Development Facilitation Team (DFT) – Review Comments

Project No: PR-2024-010462 Date: 6/12/2024 Agenda Item: #3 Zone Atlas Page: G-14

Application For: SD-2024-00104 – PRELIMINARY/FINAL PLAT

CSI – CARTESIAN SURVEYS INC. agent for D R INVESTMENTS LLC requests the aforementioned action(s) for all or a portion of: LOTS 15 & 16, DAVIDSON ADDITION NUMBER 2 zoned MX-M, located at 210 CANDELARIA RD NW between 2ND ST NW and 3RD ST NW containing approximately 0.4205 acre(s). (G-14)

FIGURE 7.2.41 Street Element Dimensions Along Major Roads

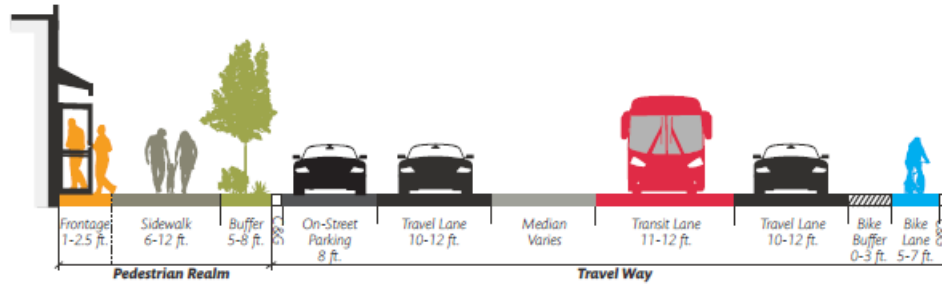
- **Confirm if there is going to be any development with driveways or drive isles.**
- **Confirm if the sidewalks are meeting the current requirement per 7.2.29 shown below.**
